SP2024-032

PROJECT COMMENTS

PROJECT NAME: Site Plan for 855 Whitmore Drive

CASE CAPTION: Discuss and consider a request by Hooman Sedaghat of Buildeng, LLC on behalf of Salvador Salcedo for the approval of a Site Plan

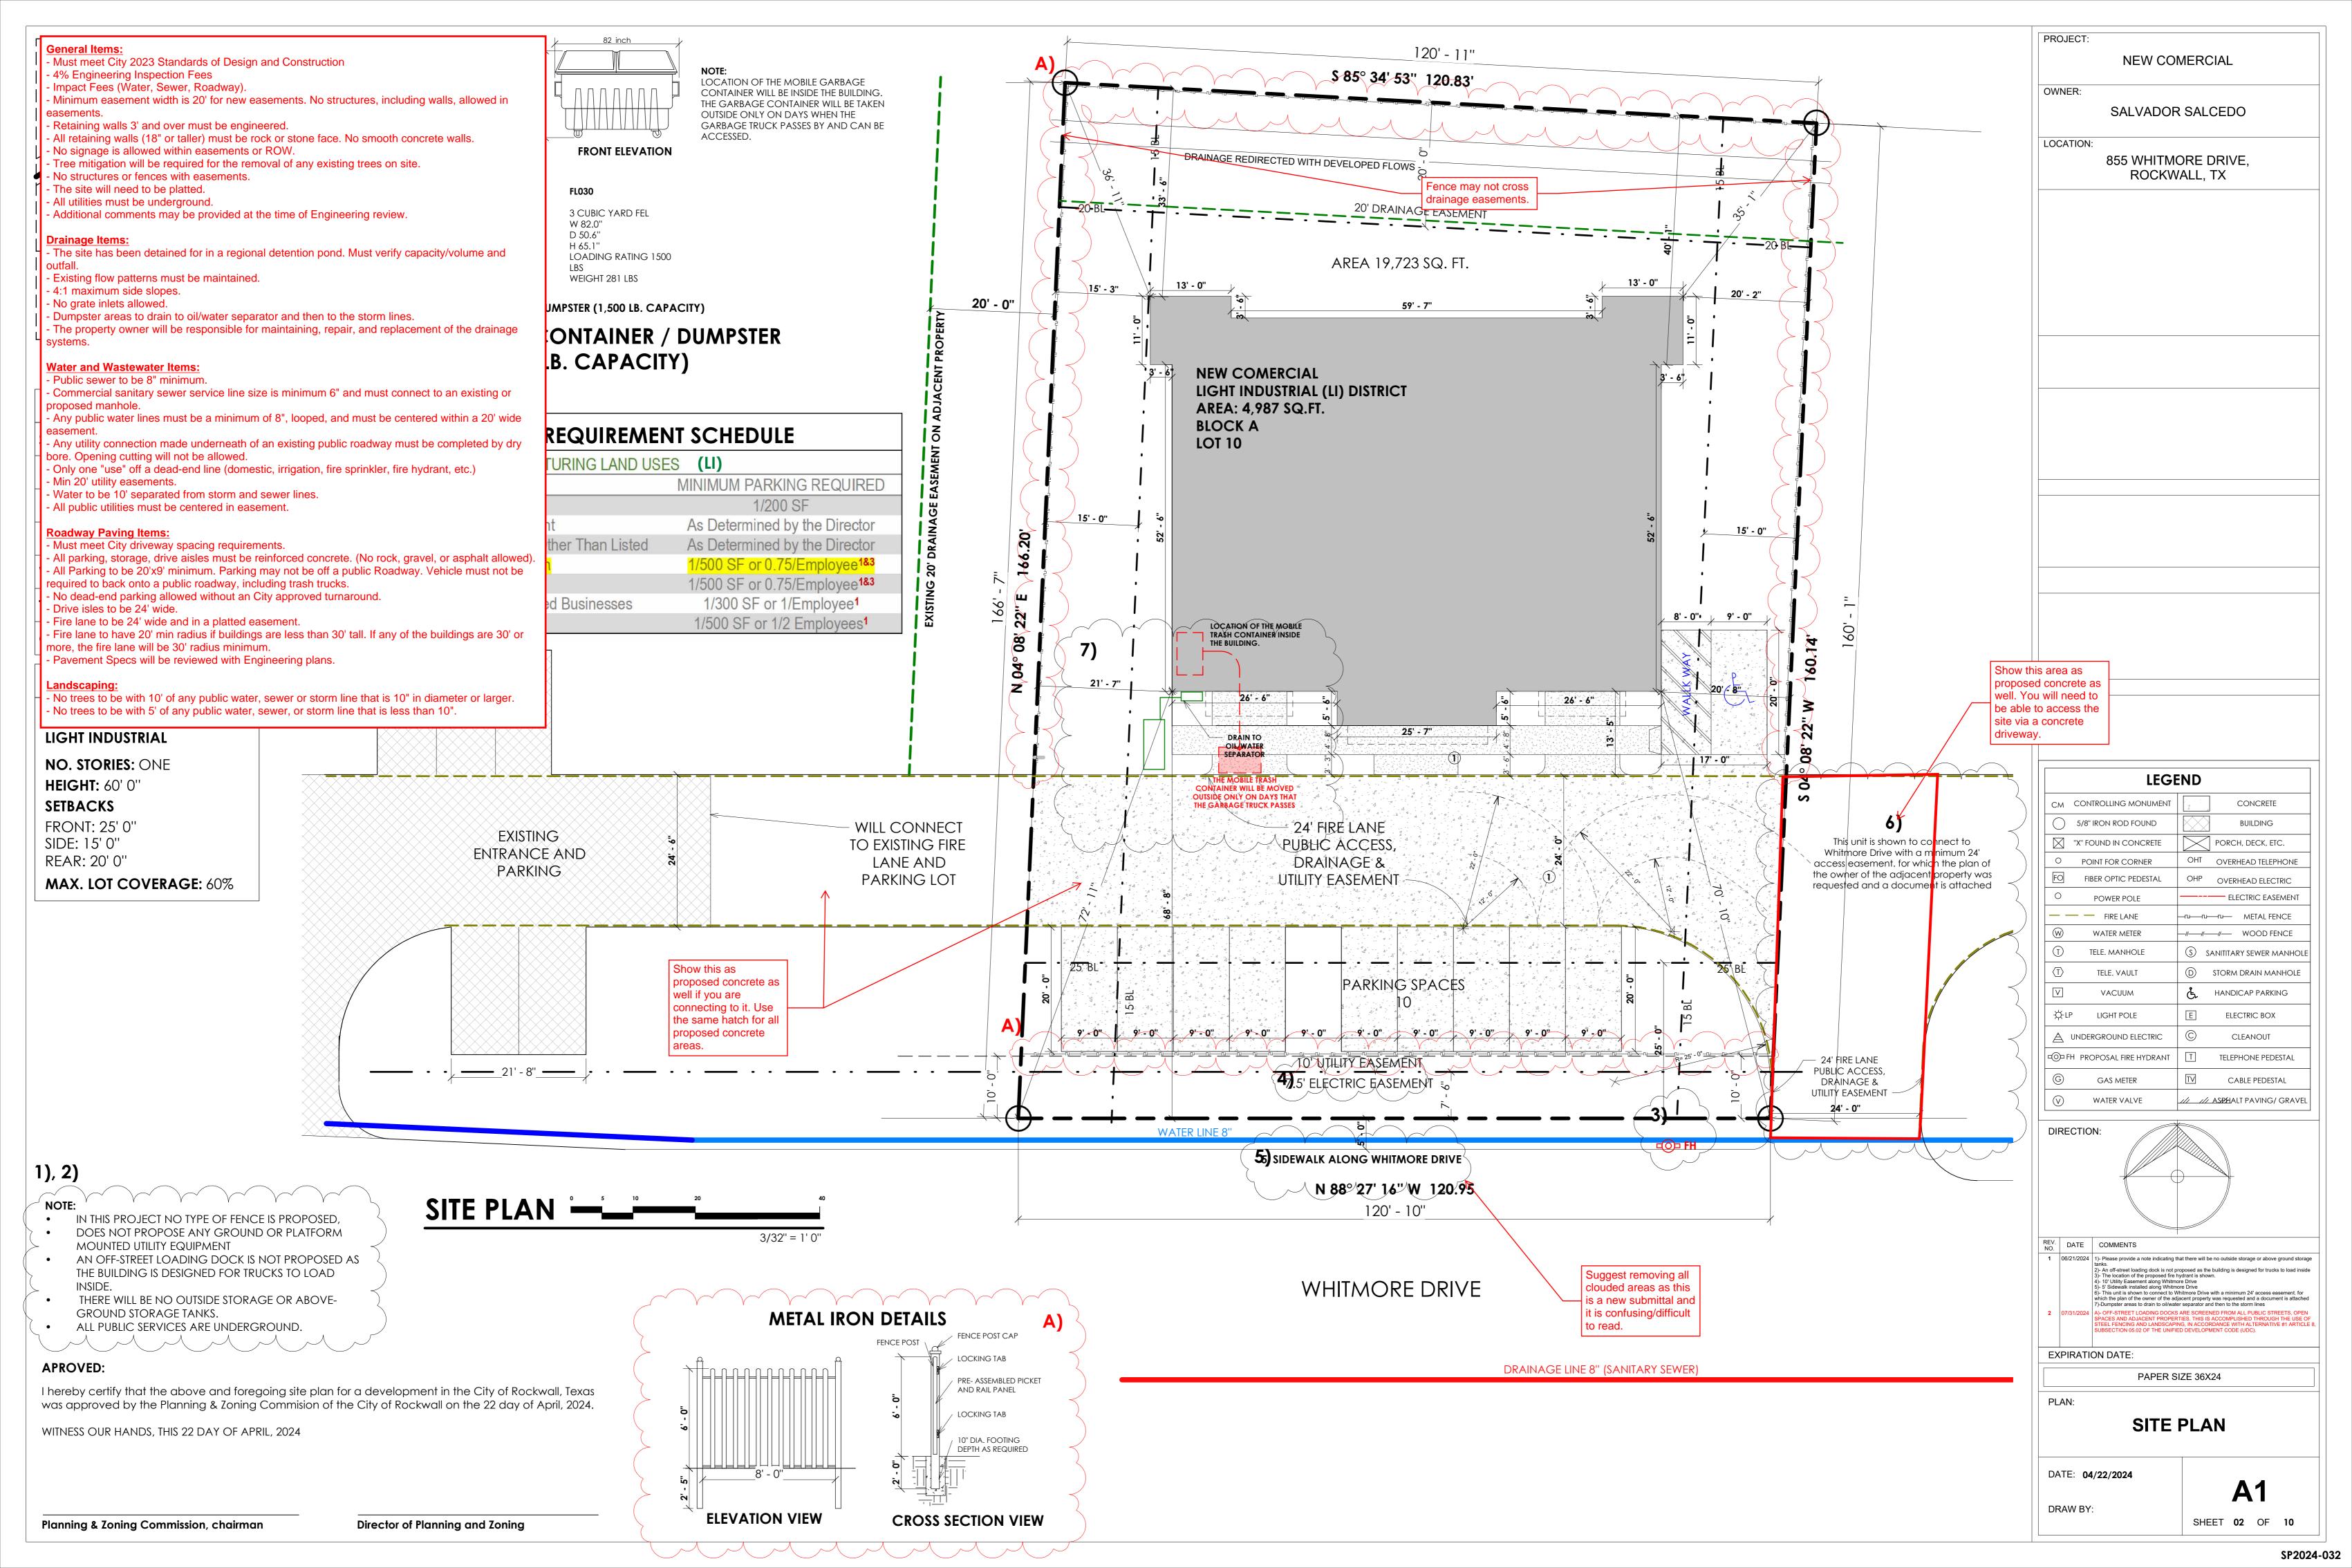
- 07/23/2025: 1. Caddo Maples are extremely hard to locate (FYI)
- 2. Make sure and wrap trunks of Maples to prevent sunscald for 1st year
- 3. Better varieties of Bermuda turfgrass that are more shade, drought, cold and wear tolerant than Common Bermuda such as Tahoma 31, TifTuf

07/23/2025: Tree mitigation approved

TREESCAPE PLAN SPRADSHEET PROTECT OR TREE HEALTH DISEASE INSECT **STRUCTURAL MITIGATION SPECIES** CALIPER REMOVE (1-5)(Y/N) (Y/N) REQUIRED (Y/N) **RED OAK REMOVE** 40''

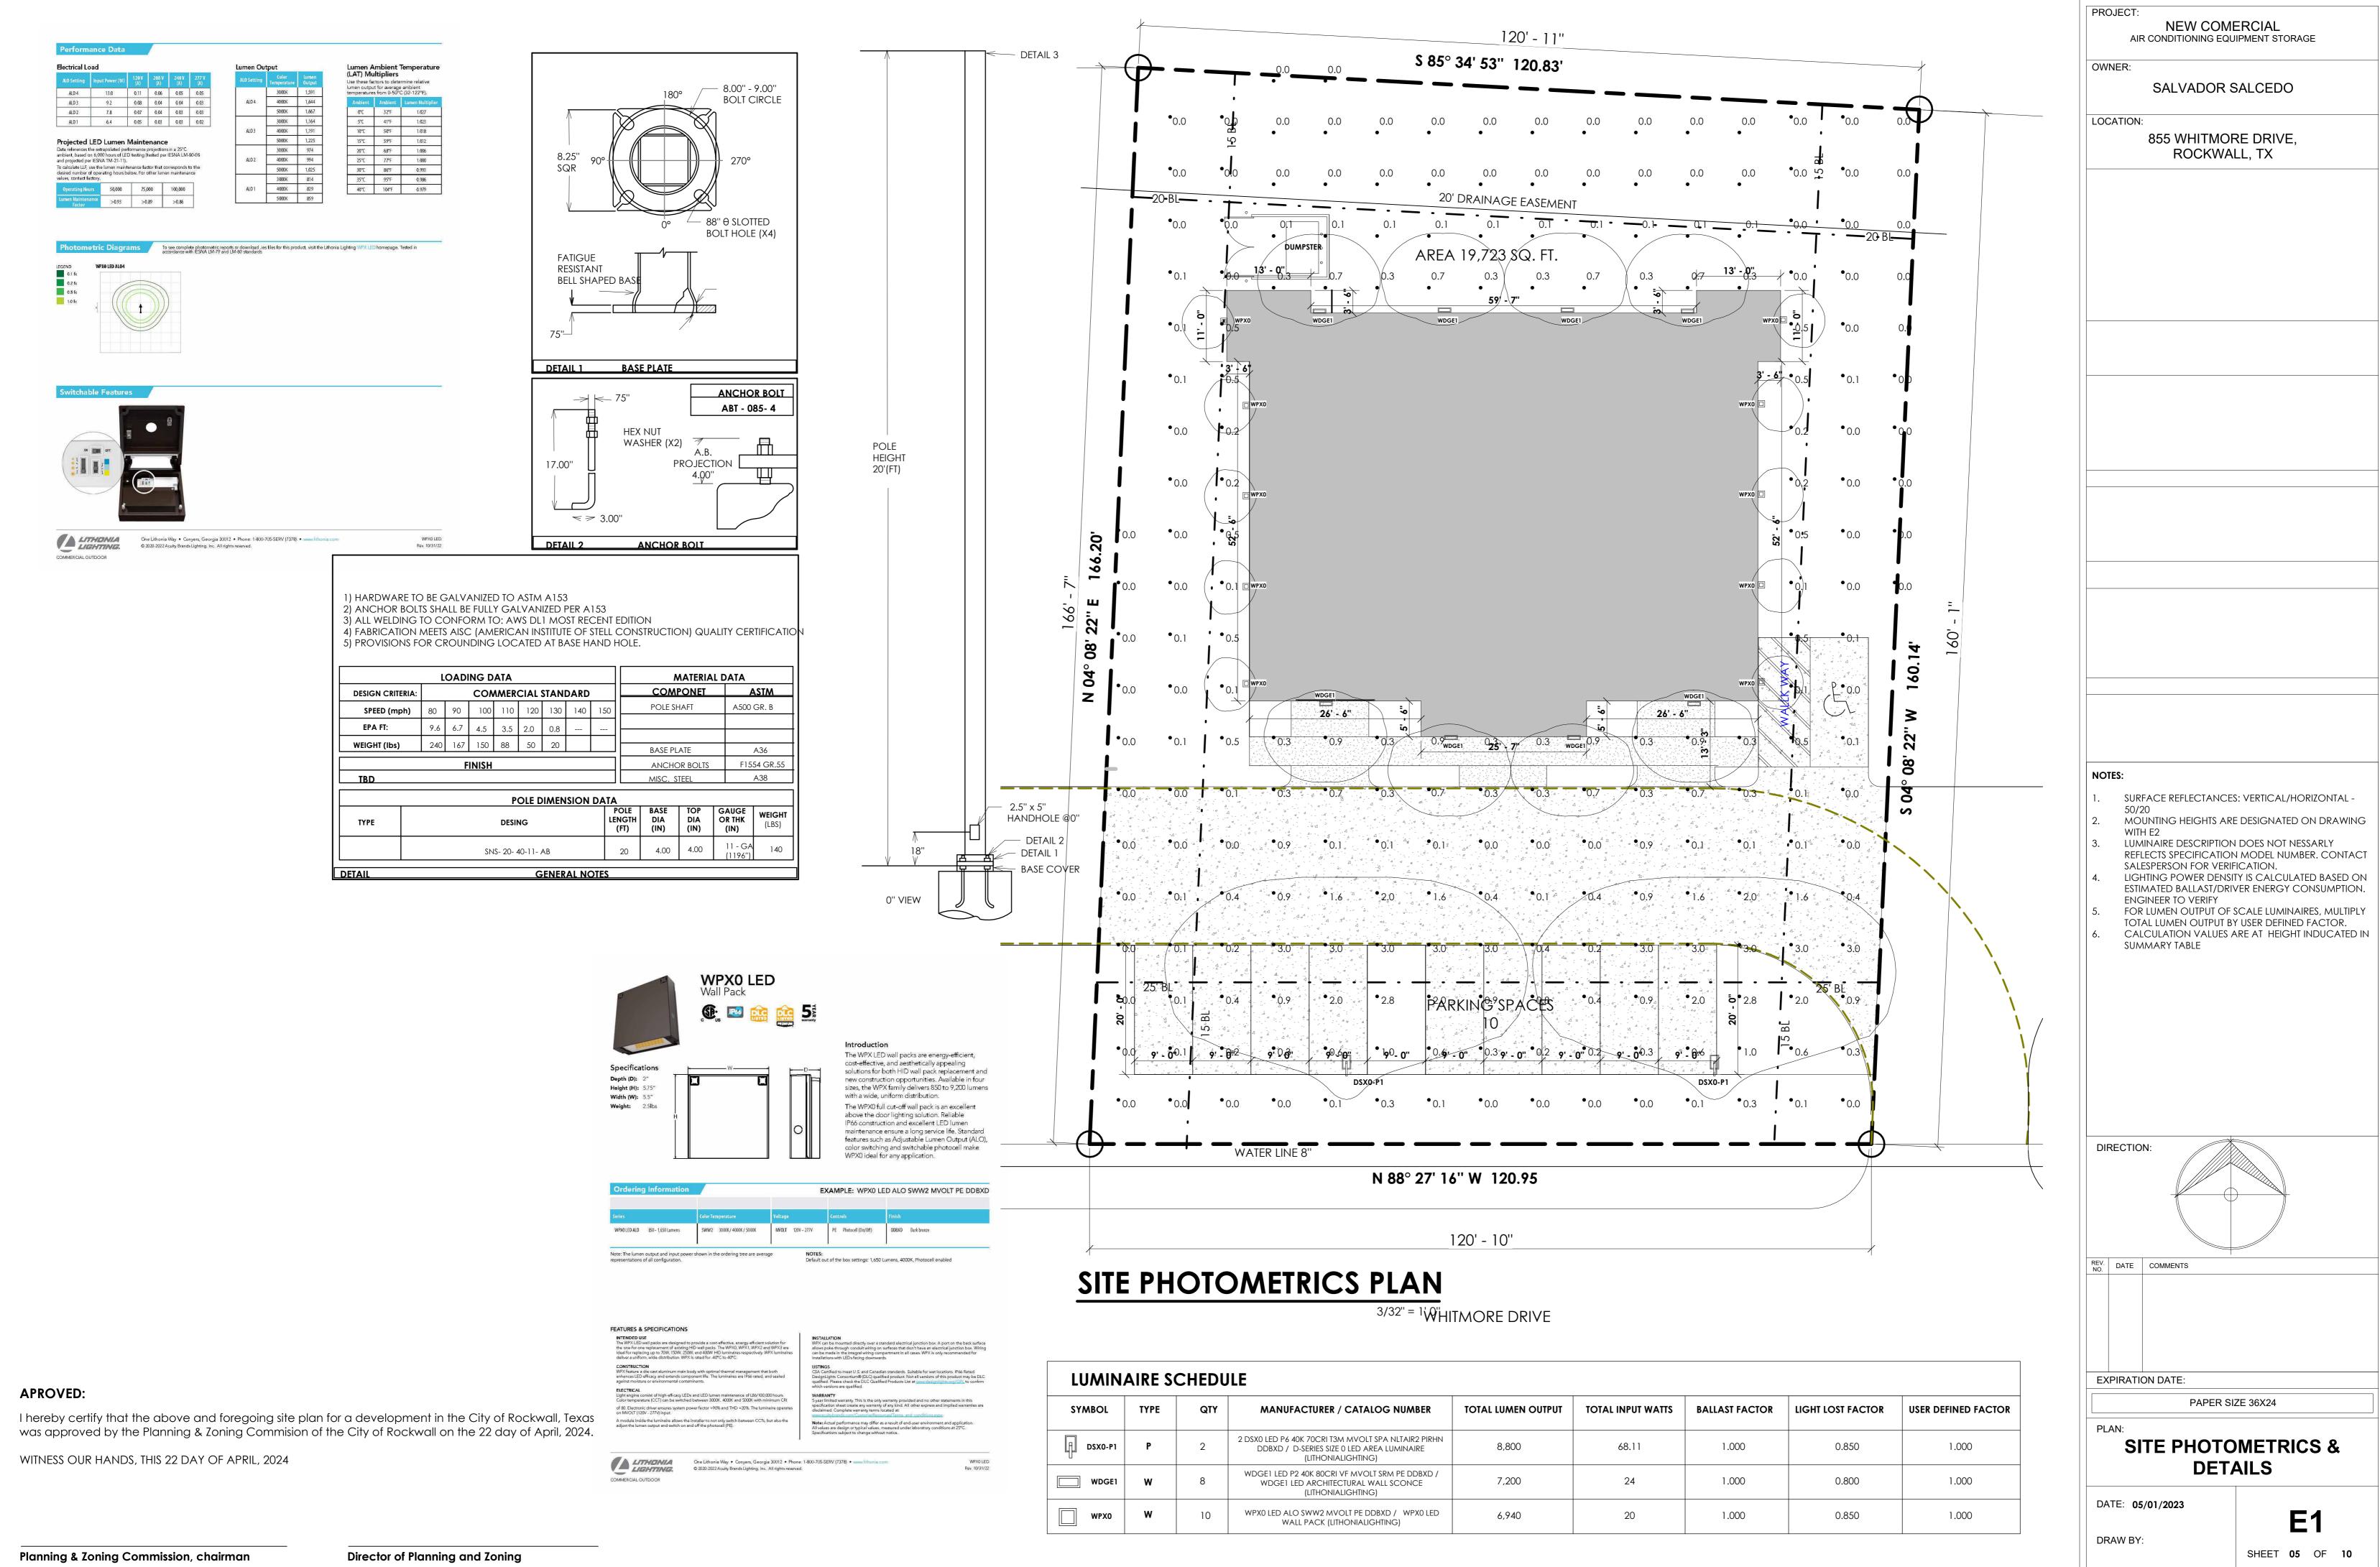
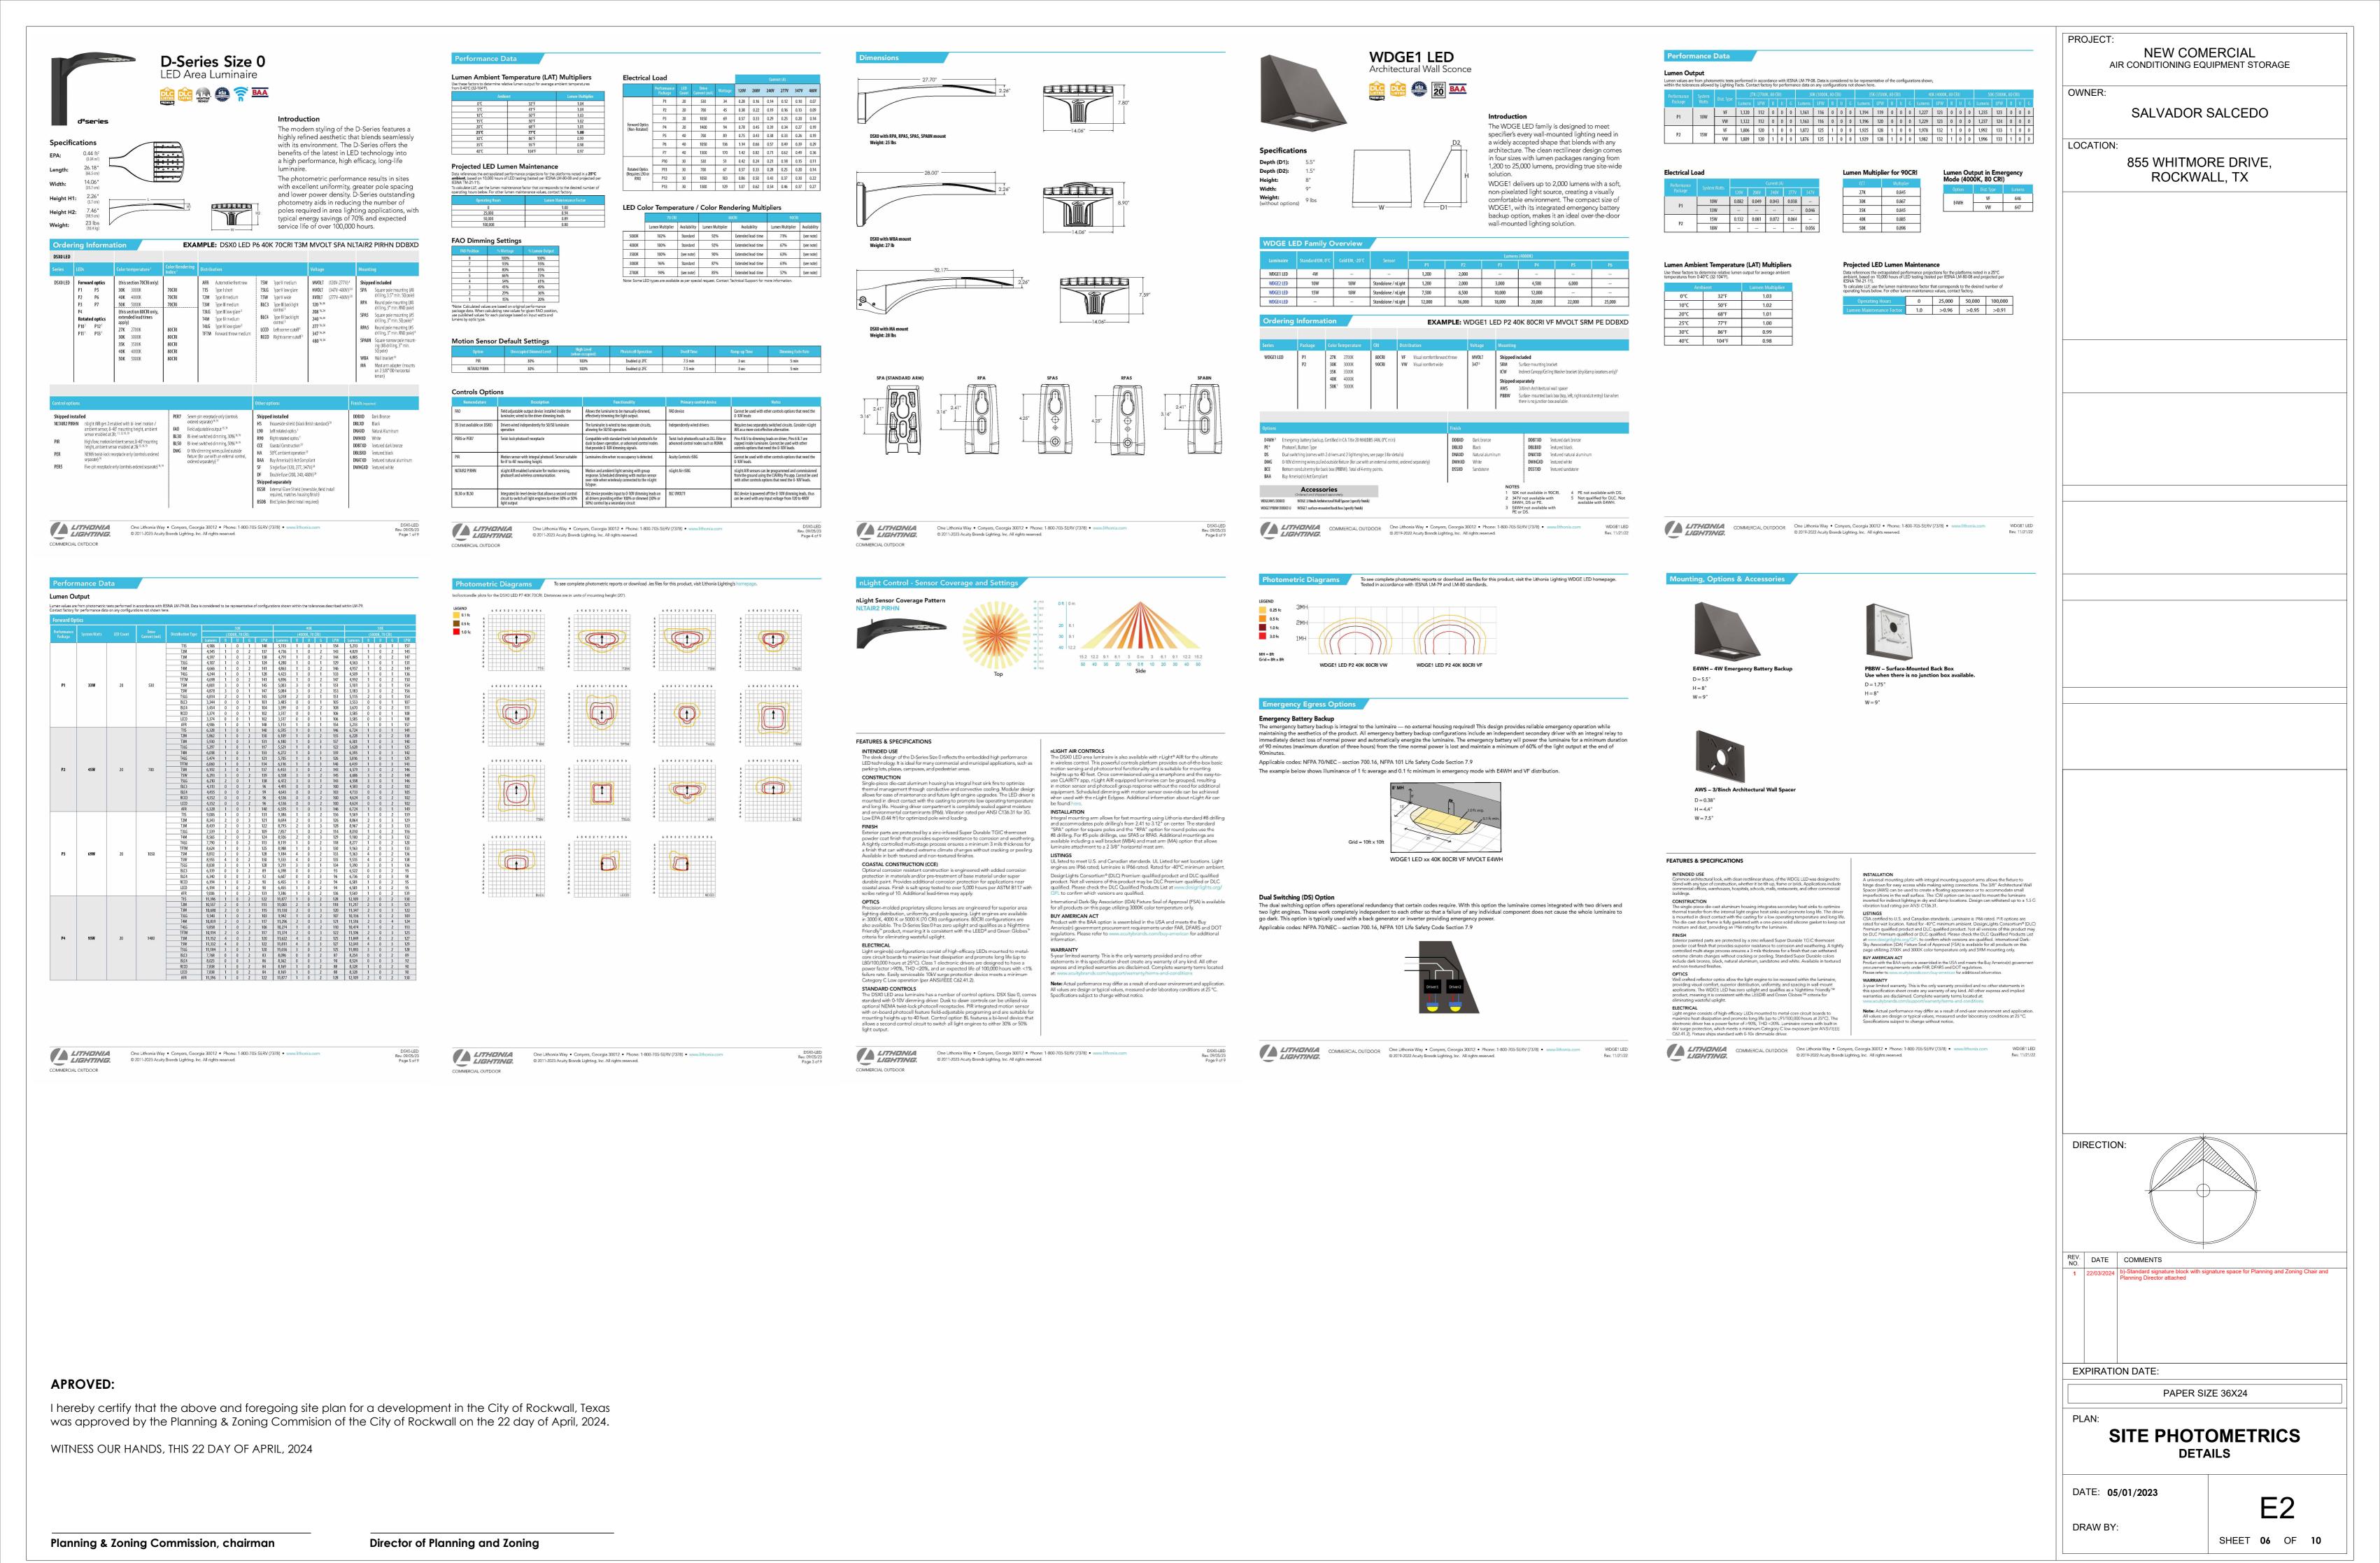
M.8 Treescape Plan

(1) The applicant is removing 40 caliper inches and planting 148 caliper inches. Given this, the mitigation is satisfied. (Section 05, of Article 09, UDC)
